Subject: MHI's Revised Responses to US-APWR DCD RAI No. 585-4464 Revision 0 (SRP 09.02.01)

Revised Responses to Request for Additional Information
No. 585-4464 Revision 0

**US-APWR Design Certification
Mitsubishi Heavy Industries, Ltd.
Docket No. 52-021**

RAI NO.: NO. 585-4464 REVISION 0
SRP SECTION: 9.2.1 – Station Service Water System
APPLICATION SECTION: 9.2.1
DATE OF RAI ISSUE: 5/10/2010

Figure 9.2.1-1 Essential Service Water System Piping and Instrumentation Diagram (Sheet 1 of 3)

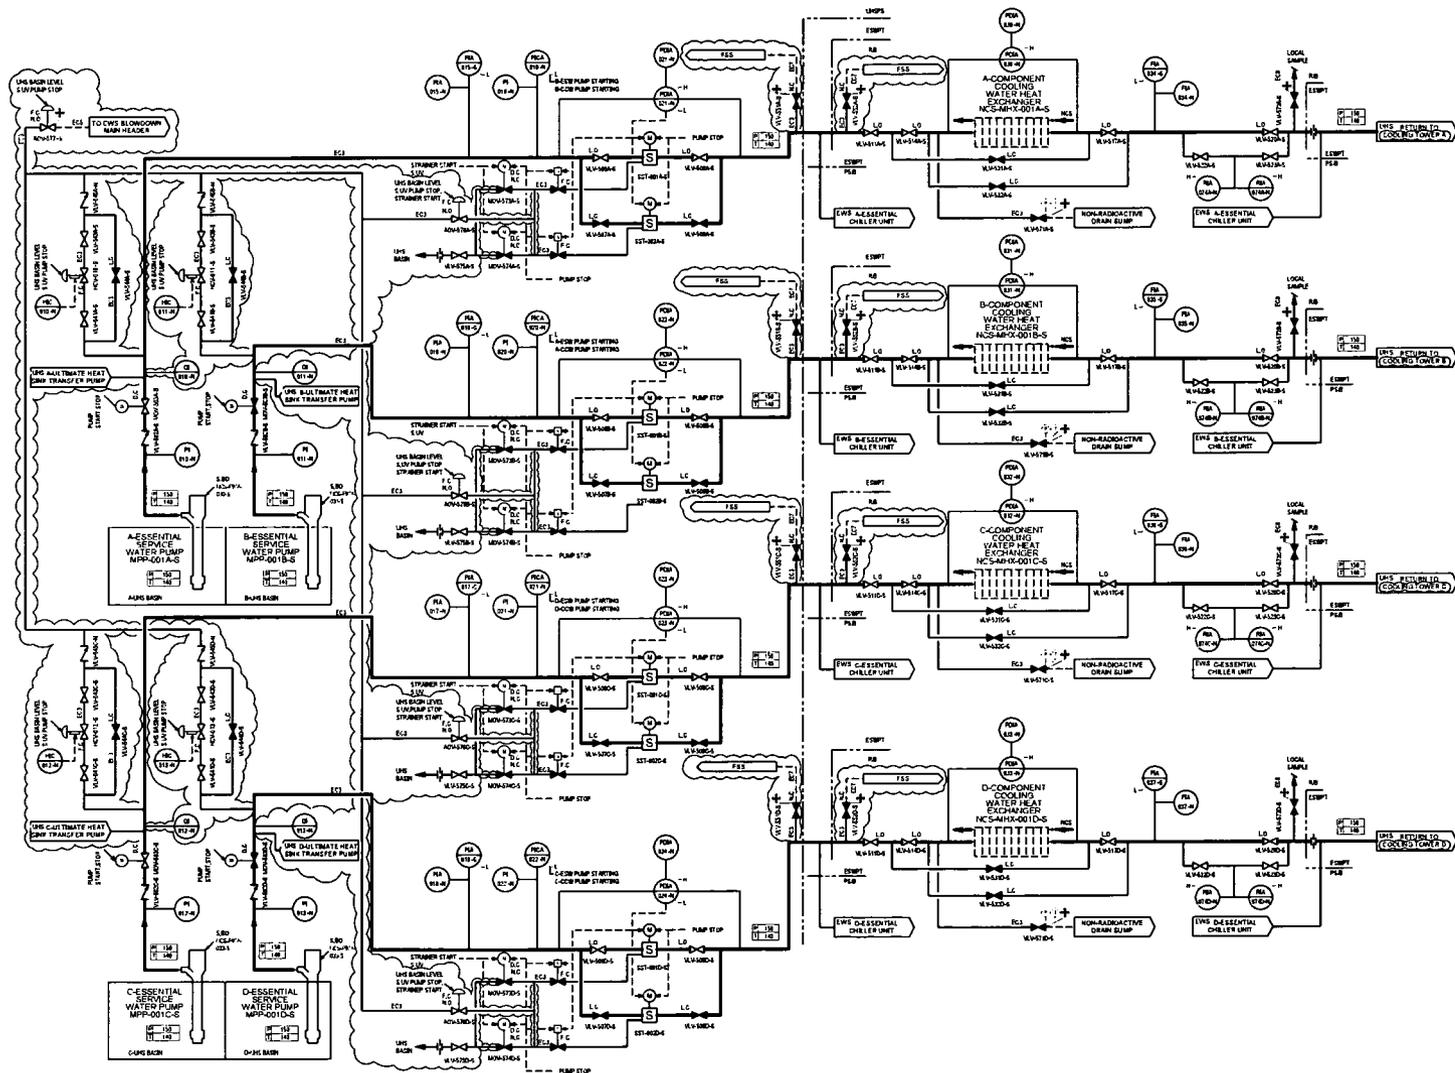
Question: n) Section 9.2.10, COL 9.2(7) indicates that the COL applicant is to provide piping and valves, including those at the boundary between safety-related and nonsafety-related portions related to site-specific conditions. It isn't clear what this item is referring to and to what extent it applies to that part of the ESWS that is within scope for the standard plant design, such as vents and drains.

The CCW heat exchanger drain connections, including drainage points, are all SPDI and have been described in DCD Figure 9.2.1-1. The Safety and Non-safety boundaries have been clearly delineated by adding the class boundary symbol delineating the first normally closed valve drain connection as "EC3" in DCD revision 3.

In DCD revision 3, by adding supplemental description to DCD Subsection 9.2.1.3, it will become clear what the COL 9.2(7) is referring to and to what extent it applies to that part of the ESWS that is within scope for standard plant design.

With regard to vents and drains, local vent/drain lines cannot be determined until the detail design phase, therefore, the design of vent/drain is not within the standard plant design. Actually, in the DCD revision 3, the system drawing has been simplified and local vent/drain lines have been deleted from the system drawing or will not be added to the drawing to prevent having to make any minor changes to the DCD as local vent/drain lines.

All instrumentation available in the main control room are also provided locally. DCD revision 3 Figure 9.2.1-1 has been appropriately revised to reflect that all instrumentation available in the MCR has local read out. The statement that all instrumentation available in MCR also has local read out will be added to DCD revision 3 Subsection 9.2.1.5.

- Subsection 9.2.1.2.2.2 is revised to state that Figure 9.2.1-1 has the valve ID markings to match the DCD description to make it clear which valves are being referred.

- The ESW flow rate to the CCW heat exchanger indication is safety-related and available in the MCR. This indication, EWS-FIA-034-S, 035-S, 036-S, 037-S which is shown in Figure 9.2.1-1, aids the operator in identifying the need for strainer backwashing. There is also a low flow rate alarm to indicate the reduction of the CCW heat exchanger performance due to the low flow rate compared to the design value of 11,000 gpm.

- The strainer swapping operation is completed.
- The inlet and outlet isolation valves for the strainers shown on Figure 9.2.1-1 do not have remote valve operator symbol; the valves can be identified as local manual valves.
